CAMDEN ROAD – NMA DESIGN DOCUMENT

CONTENT:

1. Typical shower rooms layouts compliance
2. Proposed reduced overall building height:
and additional maintenance access ladder.
3. Proposed revised cladding tile module
4. Proposed alternative finishes to rear elevation wall/deck.
5. Proposed omission of service risers along walkway.
6. Proposed revised setting out of stair core service risers.
7. Proposed larger footprint of stair core.

CAMDEN ROAD – rear elevation service risers

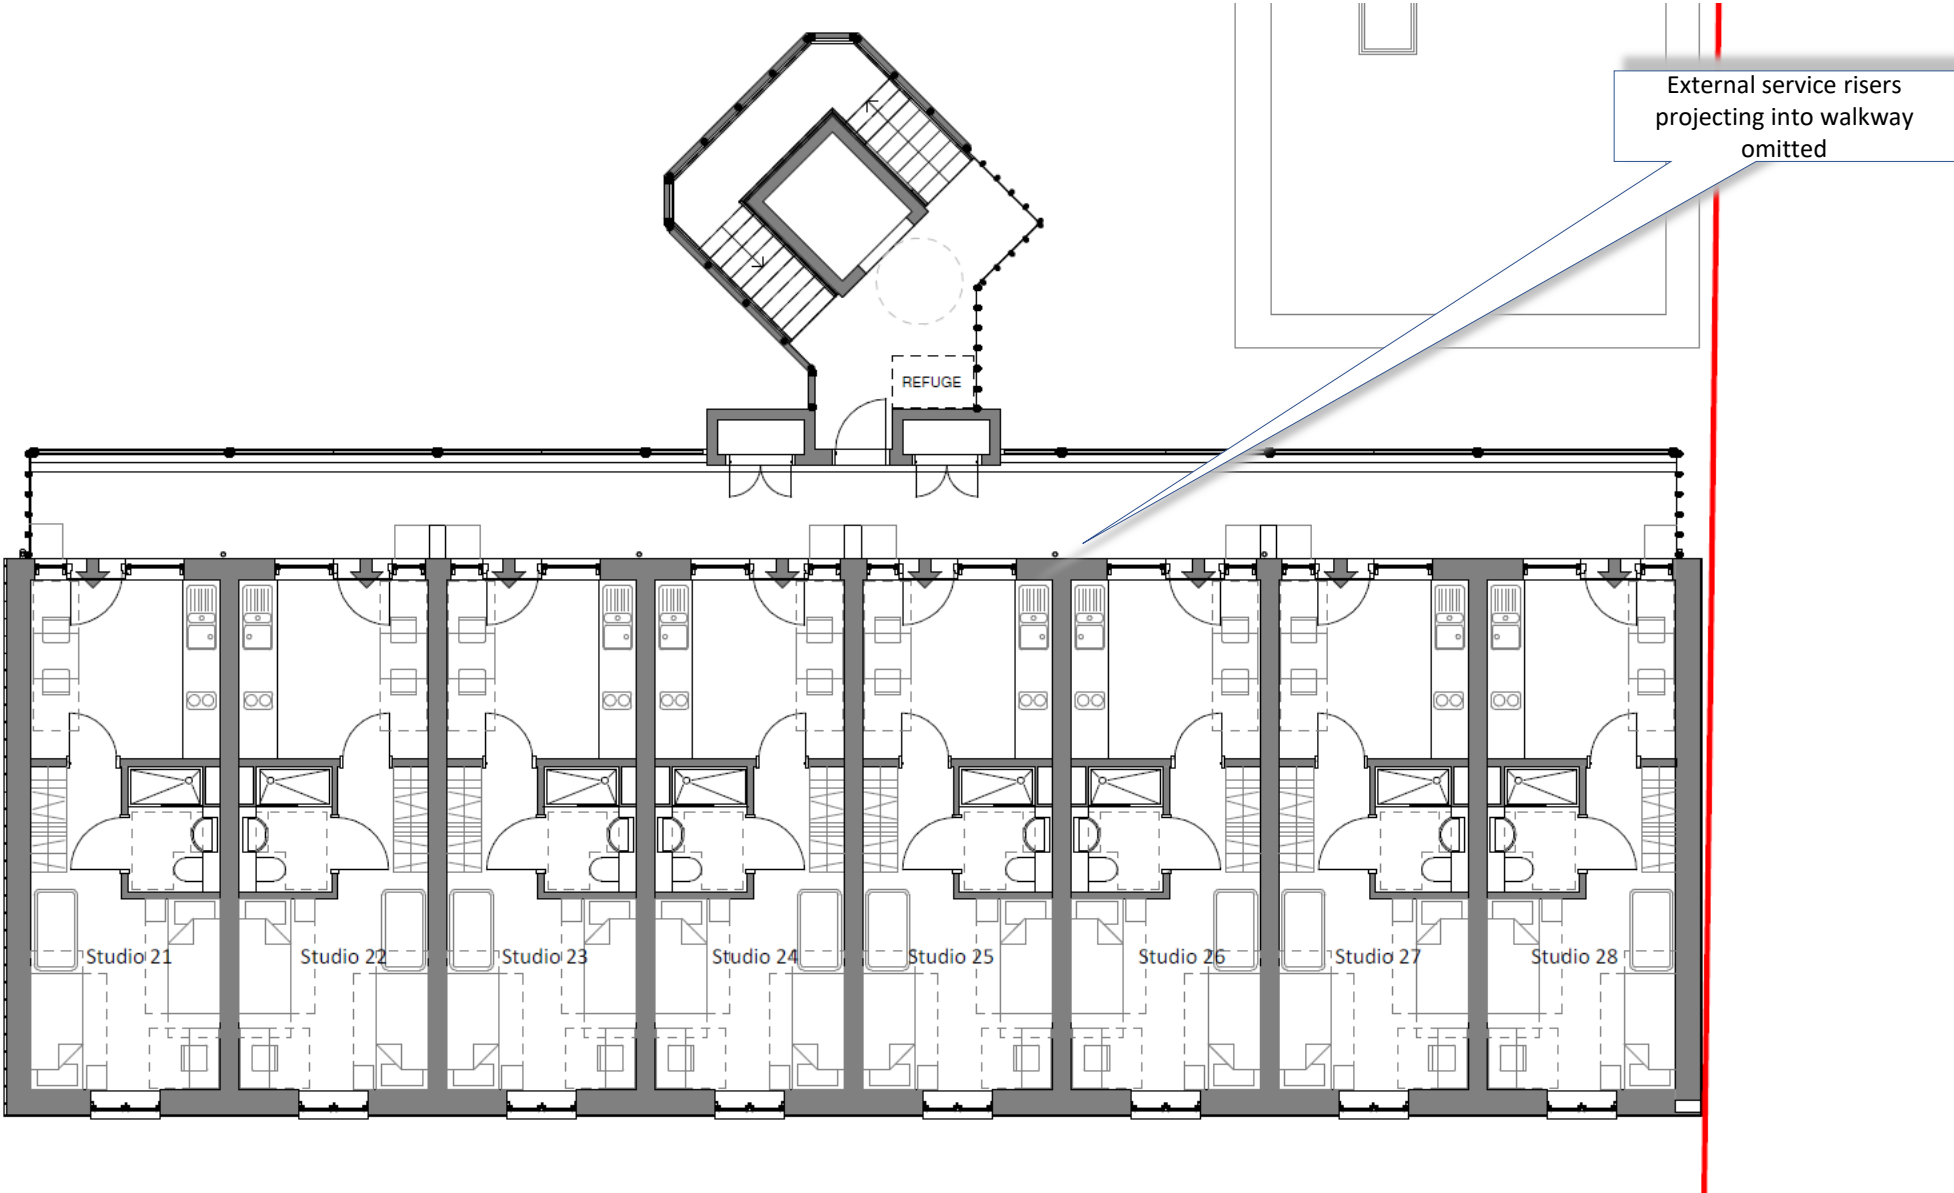
5. Proposed omission of service risers along walkway.

Service ducts projecting into the walkway area shown on the currently planning drawings were dictated by Volumetric Module System requirements.

The introduction of LGS system will allow the service risers to be incorporated within the individual unit's footprints.

Services related pipework will be located above walkway soffits.

Omission of the projecting service risers will create a wider clear walkway circulation space/fire escape route.

CAMDEN ROAD – Revised setting out of stair core risers

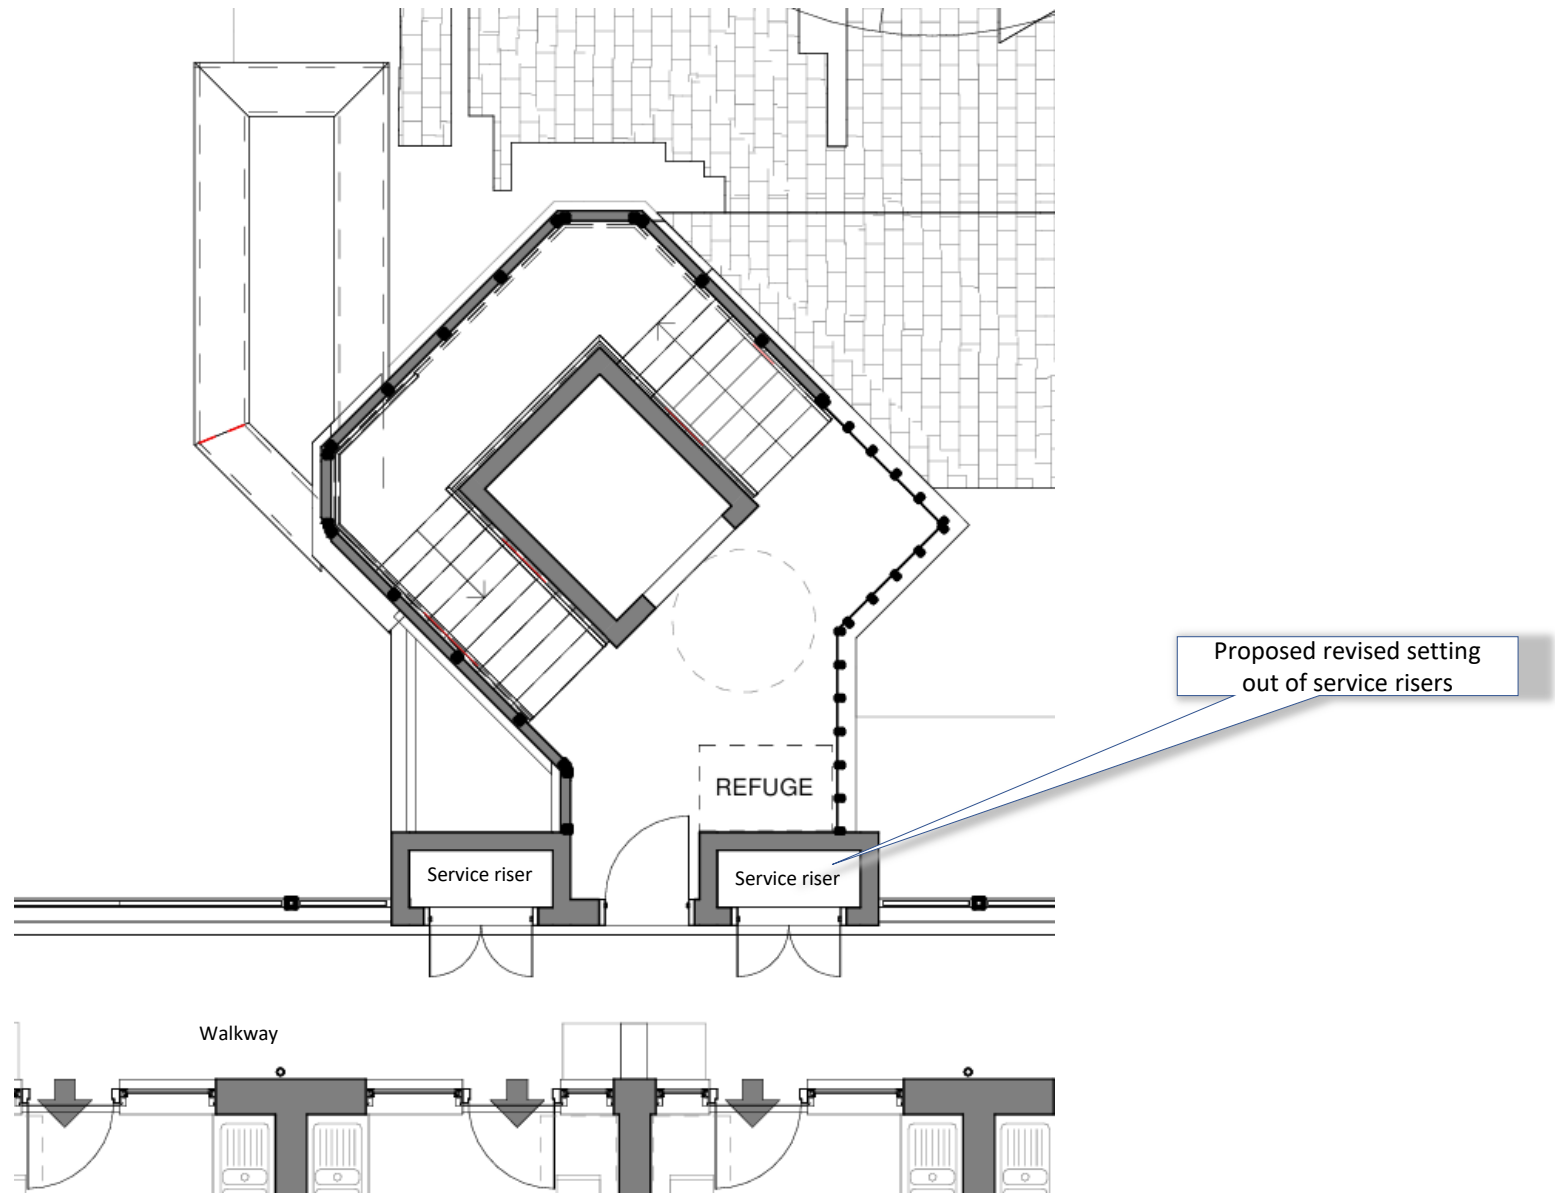
6. Proposed revised setting out of stair core service risers.

Following the design coordination with MEP Consultant the setting out of service risers had to be implemented to accommodate services and to achieve compliance with fire regulations.

The service risers had to be rotated by 90 deg. to facilitate easier transfer of services from the risers into the walkways ceiling zone.

CAMDEN ROAD – Stair Core footprint

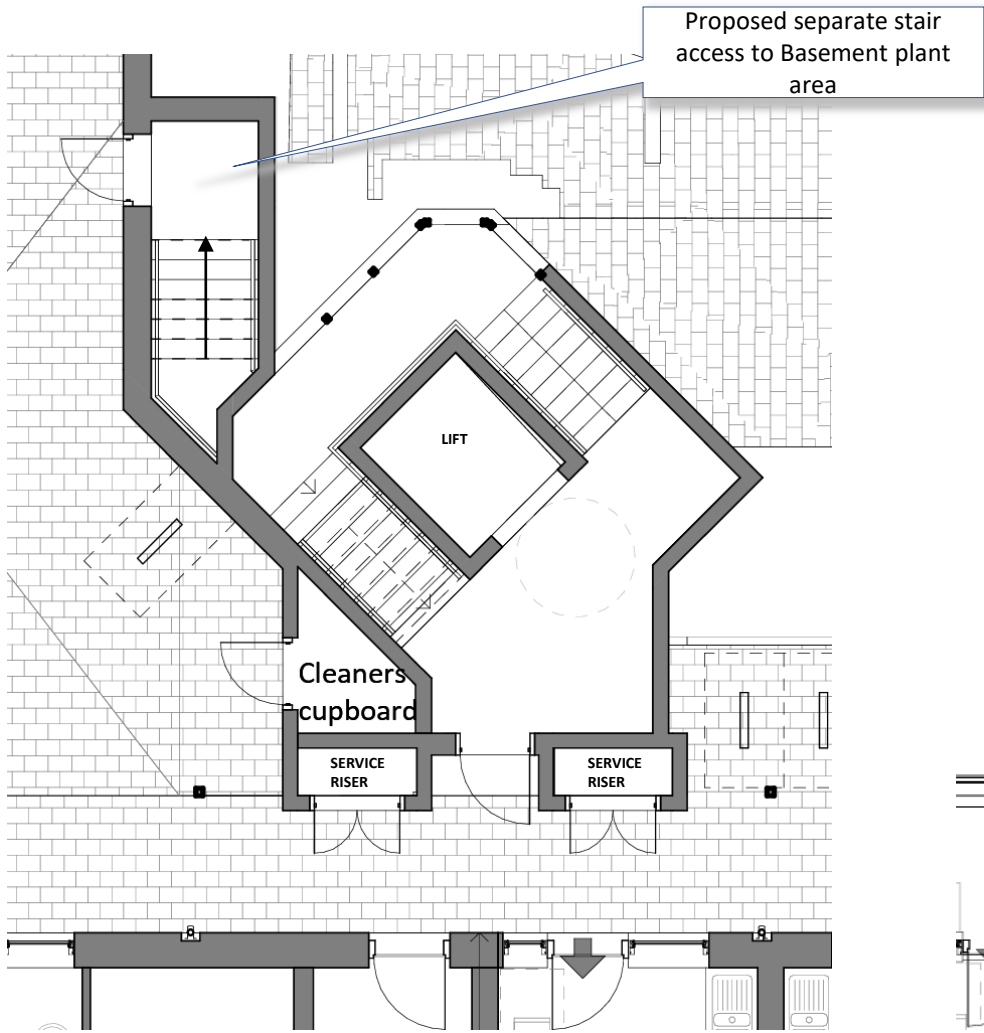
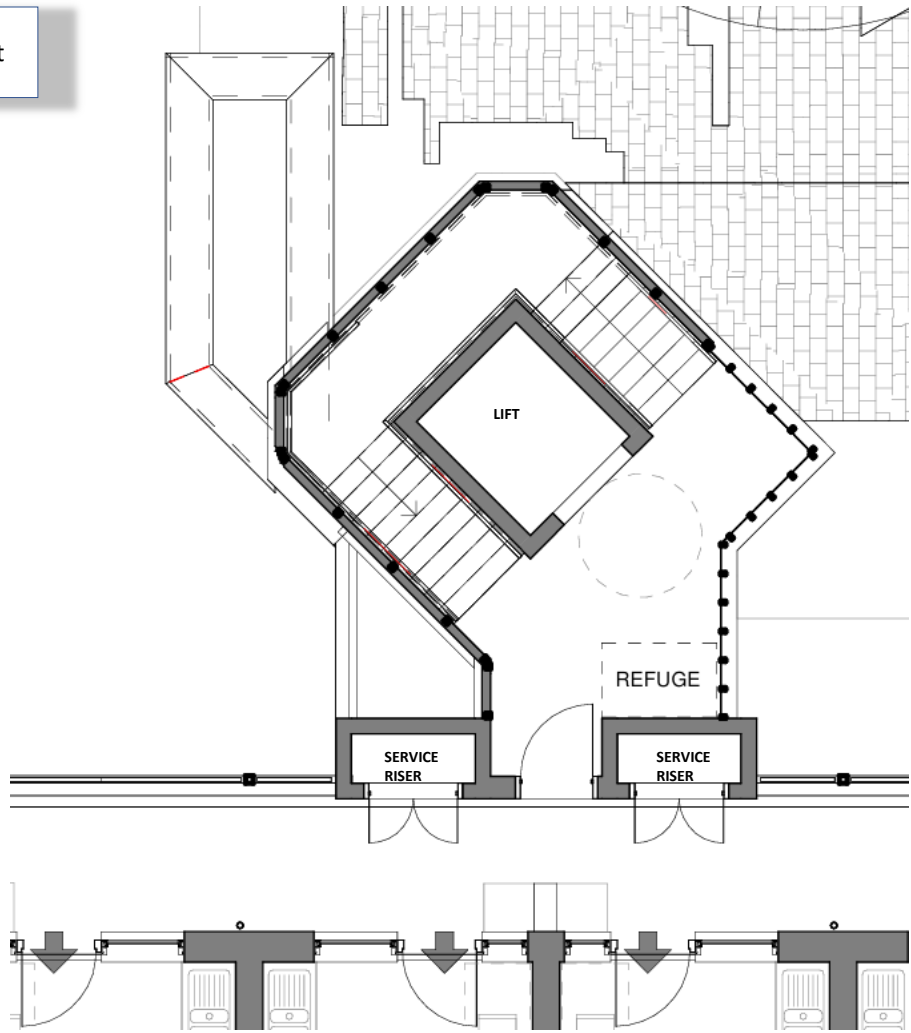
7. Proposed larger footprint of stair core.

Following a review of the maintenance strategy the location of cleaners' cupboard has been changed.

It is now proposed to be located at ground floor level instead of the basement as shown on the approved planning drawings.

Introduction of Cleaners' Cupboard at ground floor level increased the stair enclosures' footprint by 2.2 m².

Maintenance access to Basement plant area is now via a dedicated separate stair to achieve compliance with the Fire Consultant's recommendation.

The lift shaft will terminate at Ground Floor level.

Introduction of a separate Basement access stair increased the stair's footprint by 8.03 m².

The setting out of disabled refuge has been proposed following the design changes to the service risers.
